MEMORANDUM

REVIEW TYPE: Preliminary Plan of Subdivision

PROJECT NAME: Tapestry

CASE NO. 120050950

PRELIMINARY PLAN

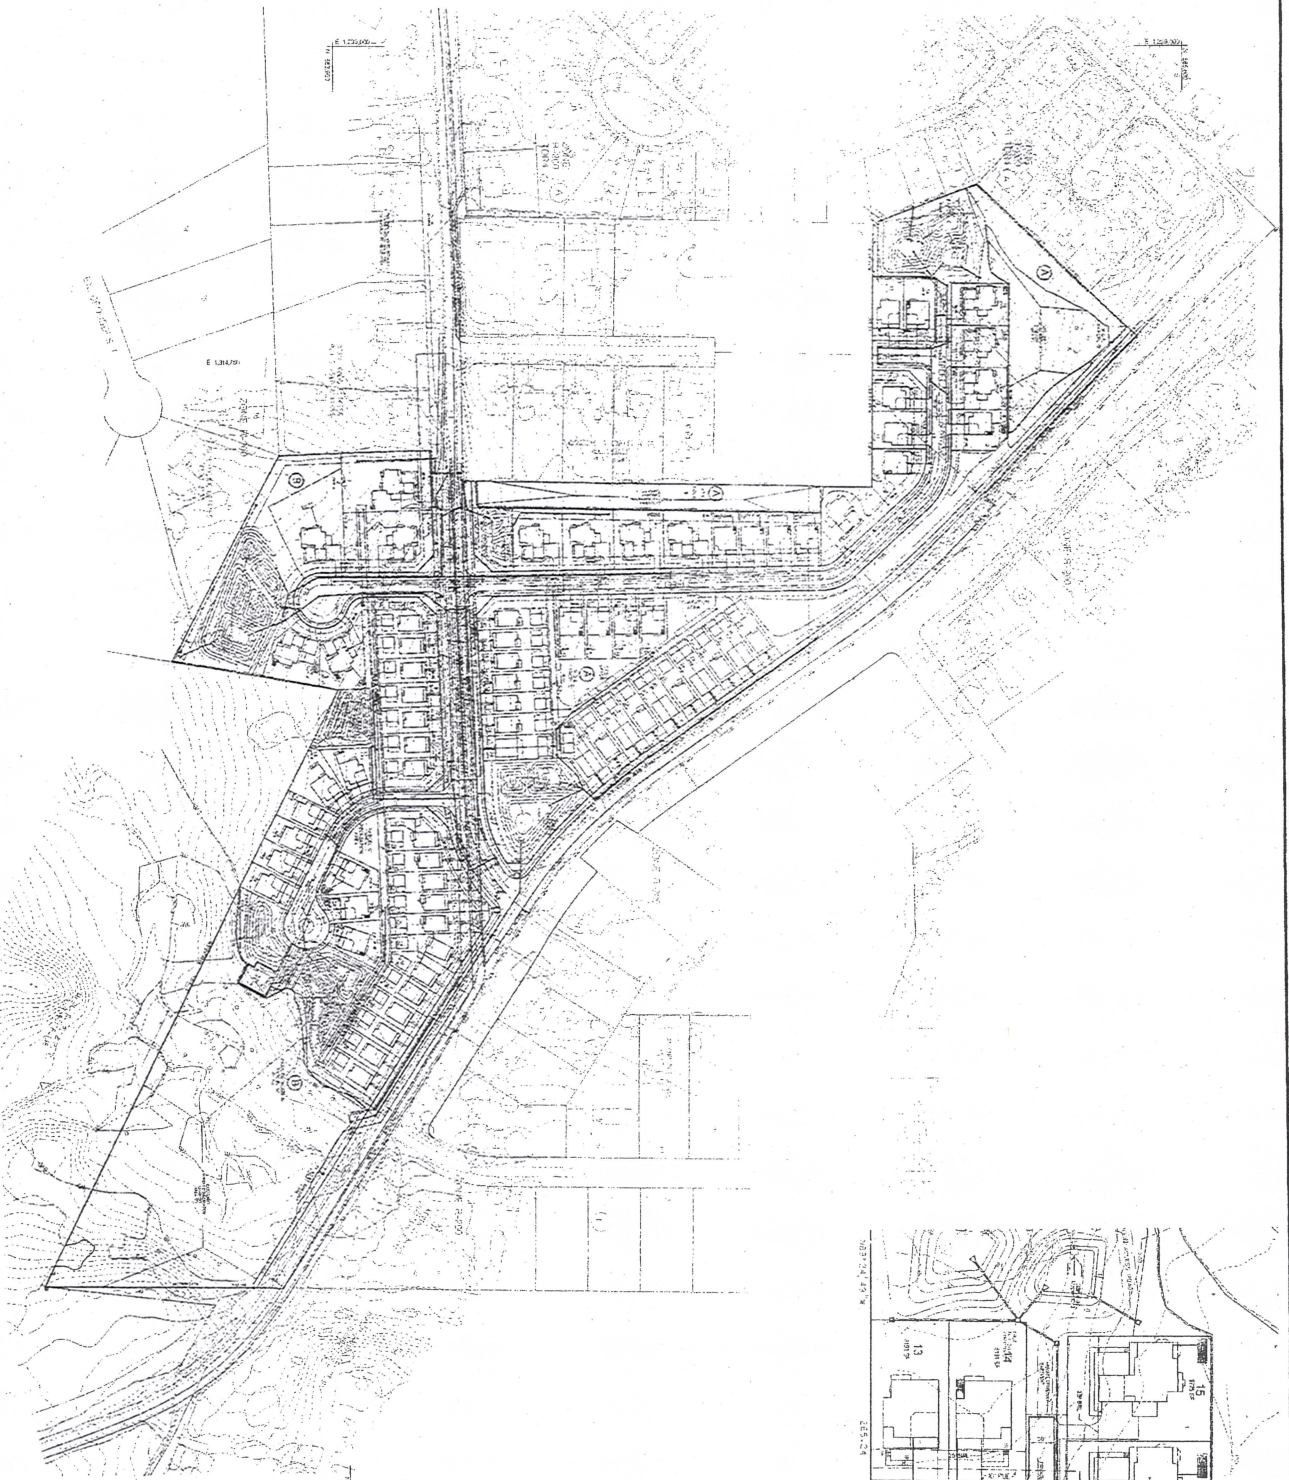
The subject preliminary plan consists of a 78-lot subdivision containing 66 one-family detached dwellings and 12 semi-detached units or duplexes. The plan shows access for all units from West Old Baltimore Road. Internal access is provided by a combination of public streets and private alleyways. Streets "A" and "D" serve the units north of West Old Baltimore Road. Streets "B" and "C" are the two public streets that serve the units on the south side of West Old Baltimore Road. All four streets are classified as tertiary, with 50-foot right-of-ways except for

- 1) Approval under this preliminary plan is limited to 78 lots for 66 one-family detached, and 12 one-family semi-detached residential dwelling units, including a minimum 15% moderately priced dwelling units (MPDUs).

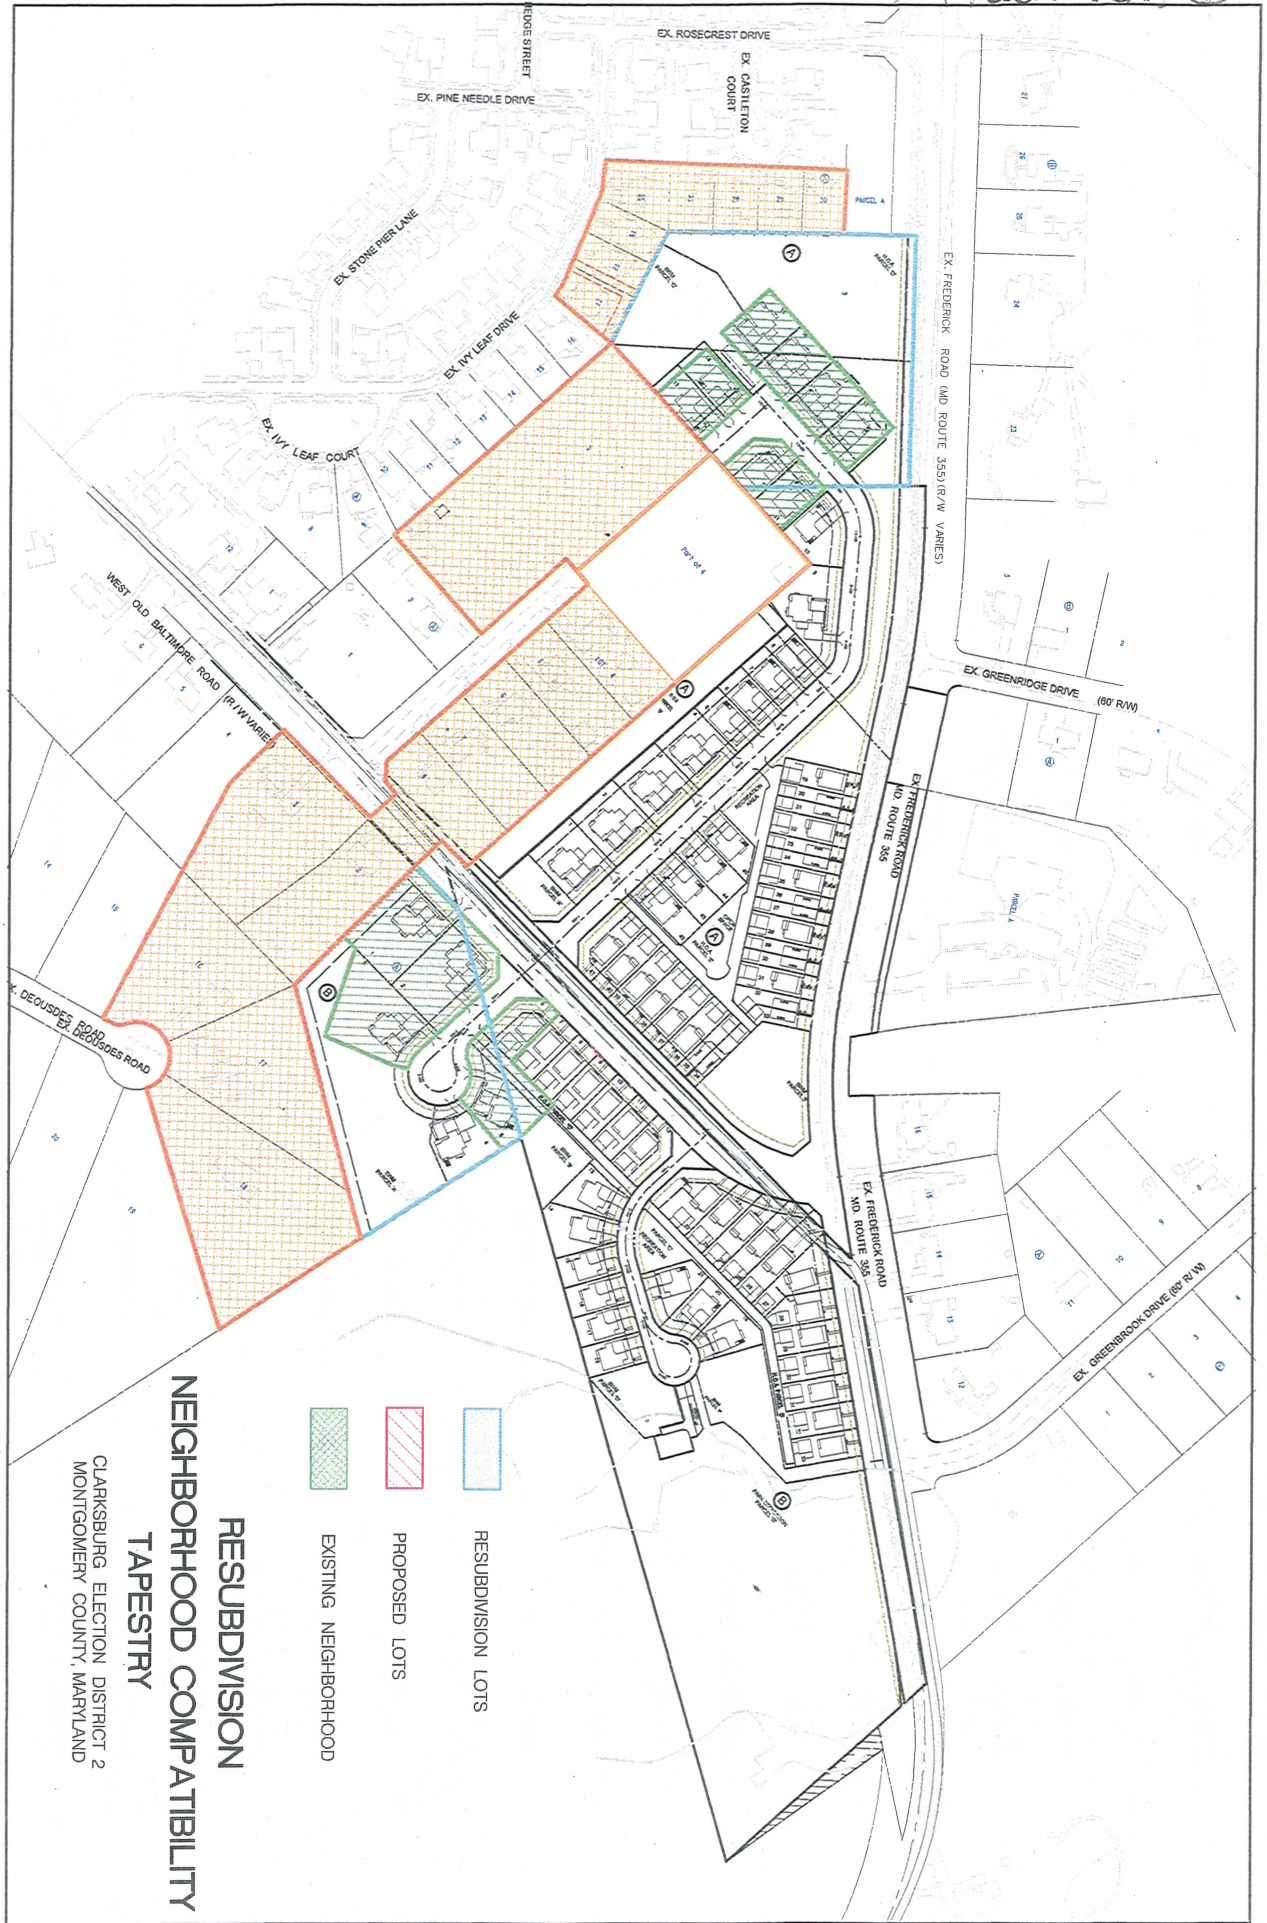
The proposed plans generally achieve this objective. As shown on the proposed site plan, there are six (6) units backing onto MD 355, at the northern edge of the property, adjacent to the Forest Conservation Area. The existing mature trees will block the view of lots 15 through 19 from MD 355. Since lot 20 will be visual from MD 355 (its rear and side), staff suggests its deletion or the continuation of substantial planting, such as, 8-foot high evergreens, to screen its view from MD 355.

With the proposed revisions, the site plan would achieve the Master Plan objective.
